Work Order ID 93131

Item Name: Lug

DRAWING NO. D3394	TITLE LUG	REV. B	DART AEROSPACE LTD ENGINEERING ORDER		D.E.O. NO. D3394-B-1	SHEET NO. SHEET 1 OF 1	SCALE NTS
DRAWN AJS	CHECKED	MFG. APPR.	APPROVED	DE APPR.			
DATE 09.11.04	DATE 09.11.04	DATE 09.11.04	DATE 09/11/04	DATE 09/11/04

DRAWING NO. D3394	TITLE LUG	REV. B	DART AEROSPACE USA, INC ENGINEERING ORDER		D.E.O. NO. D3394-B-2	SHEET NO. SHEET 1 OF 1	SCALE NTS
DRAWN GP	CHECKED SC	MFG. APPR. M	APPROVED MP		DE APPR. H		
DATE 11.05.02	DATE 11.05.09	DATE 11.05.09	DATE 11.05.09		DATE 11.05.09

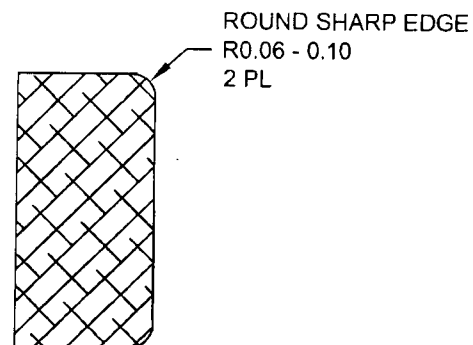
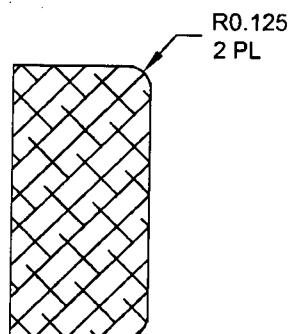
SHEET 4 ZONE A,1 MODIFY SECTION A-A AS SHOWN:

REASON: DRAFTING ERROR

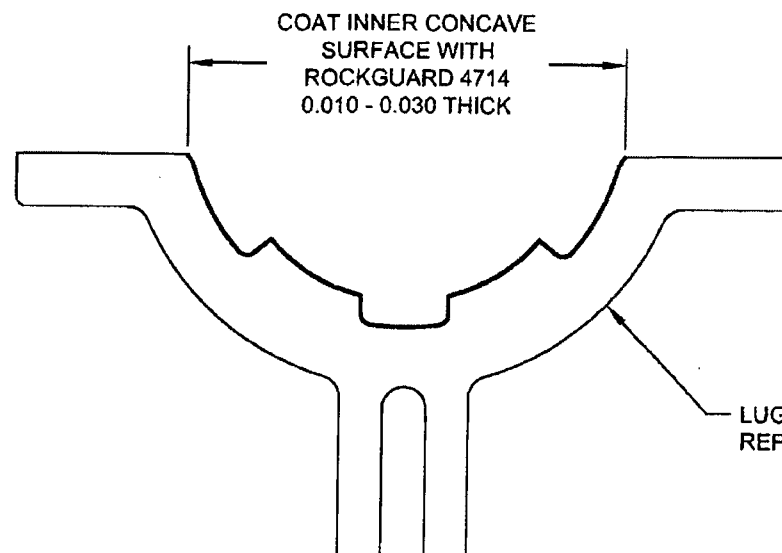
ADD D3394-xRG OPTION

D3394-xRG MOUNTING LUGS ARE IDENTICAL TO D3394-x MOUNTING LUGS, HOWEVER AFTER FINISH, COAT INNER CONCAVE SURFACE WITH "PLUS ONE ROCKGUARD 4714" AS SHOWN BELOW.
